KEI MOUTH HOTEL AND APARTMENTS

RESPONSE TO BASIC ASSESSMENT REPORT

APPENDIX AA

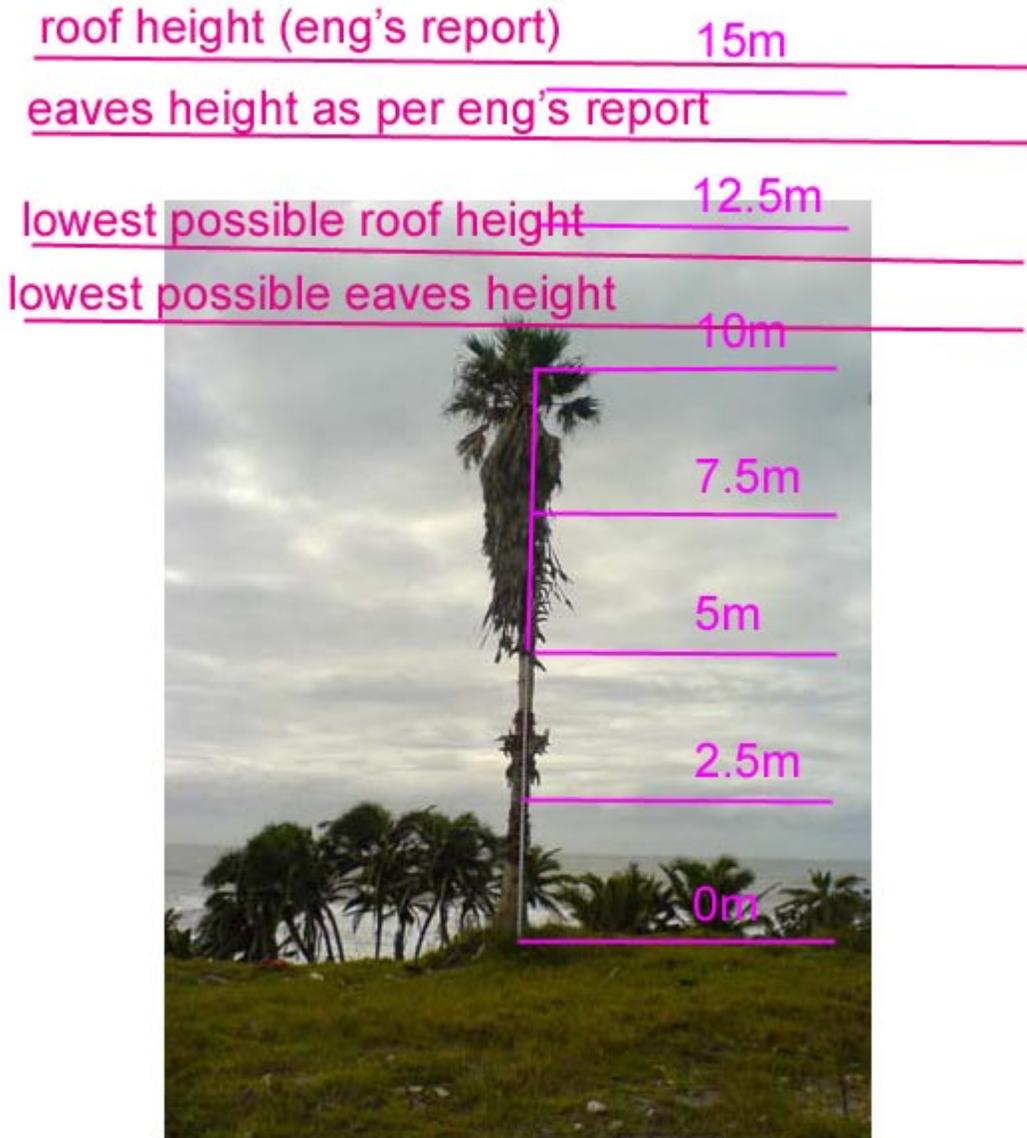
- The only reference to a possible height for the building is the 3.5m floor to floor height mentioned in the engineering report in the context of water pressure. The national building regulations provide that a habitable space requires a minimum of 2.4 m clear head height. Assuming a structural slab and beam depth of 300 mm this provides a floor to floor height of 2.7m. (of note in this regard is that 2.4m is an unpleasant height to use for deep spaces, which these are, and would not be considered for an upmarket development, which this purports to be). Taking the above range of figures into account, along with an allowance for the pitched roof as indicated in the architects impressions, and transposing them onto the palm tree with the 5 metre staff, it is clear that the architects impressions are extremely misleading. Refer to Appendix AA below

Figure 1 – visual impact from beach

Figure 2 – this is the minimum real impact

Figure 3 – Old hotel

Figure 4 – Misleading Building proposal presented – pink line represents minimum real impact

Figure 5 – View to old hotel

Figure 6 – Misleading Building proposal presented – pink line represents minimum real impact note end walls are blank!

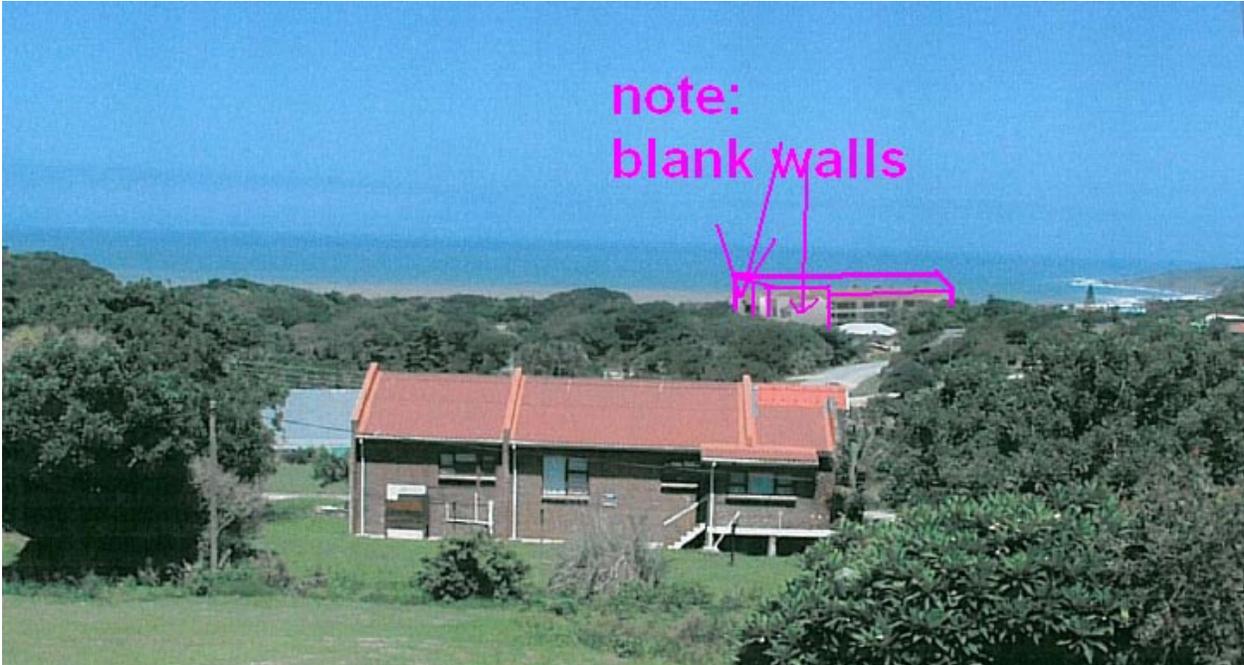
- The units are not 'upmarket' – they are 'bare minimum' apartments.
 - Given the sheer size of the proposed development (with 4 storey high blank end walls!) it cannot be considered more visually appealing than the old hotel, which was modest in comparison.

Figure 7 – view to old hotel

Figure 8 Misleading building proposal presented – pink line represents minimum real impact
